# UNITED STATES PATENT AND TRADEMARK OFFICE

APPLICATION NO.	FILING DATE	FIRST NAMED INVENTOR	ATTORNEY DOCKET NO.	CONFIRMATION NO.
10/725,756	12/02/2003	Joseph J. Lacey	137023-24CT	3271
26946	7590	06/27/2005	EXAMINER	
JOSEPH S. HEINO, ESQ. 111 E. KILBOURN AVENUE SUITE 1400 MILWAUKEE, WI 53202			THOMAS, COURTNEY D	
			ART UNIT	PAPER NUMBER
			2882

# Office Action Summary

6. Figure 5 - X-ray CT detector (3<sup>rd</sup> embodiment) – U.S. Patent 6,411,672 to Sasaki et al.

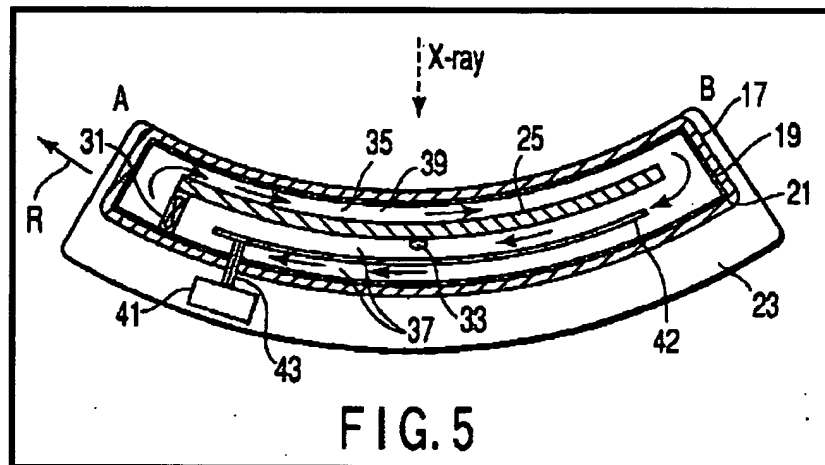
7. As per claims 1-14, Sasaki et al. disclose an apparatus (and method) comprising a hot air plenum (35) a heat exchanger (41, 42, 43), a cold air plenum (37) circulation fan (31), temperature measuring device (33) and temperature controller (not shown above - see column 4, lines 26-34; 63-65). Examiner correlates electronics as element (25) in Fig. 5 above. Sasaki et al. do not explicitly disclose the heat exchanger as being a thermoelectric cooler.

8. Chu teaches that thermoelectric coolers (TECs) employ the Peltier effect, similar to conventionally known heat exchange systems, however TECs offer advantages of being compact, quiet, and having no moving parts. Chu cites TECs as having the ability to control cooling by enabling a user to control the current supplied to the TEC (p. 273). Chu additionally teaches that TECs are configured with heat sinks to further dissipate component heat load, thereby contributing to a TEC's coefficient of performance (see Abstract; p. 274).

9. It would have been obvious to one having ordinary skill in the art at the time the invention was made to modify the apparatus of Sasaki et al. such that it incorporated a thermoelectric cooler. One would have been motivated to make such a modification for the purpose of employing a compact, quiet, cooling element with no moving parts and controllable via application of current as suggested by Chu (see pp. 270-274; 278).

Figure 1 - Prior Art Heat Sink - U.S. Patent 6,668,910 to Gawve

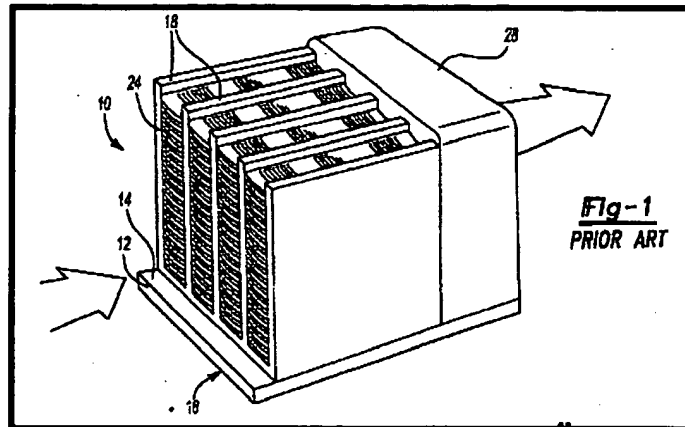
13. As per claim 26, Gawve, discloses a method comprising the step of providing a heat sink; moving heat away from electronics to the heat sink and providing a cooling fan (28) to facilitate heat dissipation over the heat sink (see Abstract; column 1, lines 5-10; 23-41; 65-67; column 2, line 1).

16. U.S. Patent 6,668,910 discloses a heat sink comprising a blower cage (18) containing a spreader plate (12) and a fan (28), configured to blow air across the heat sink (see Abstract; column 1, lines 5-10; 23-41; 65-67; column 2, line 1).
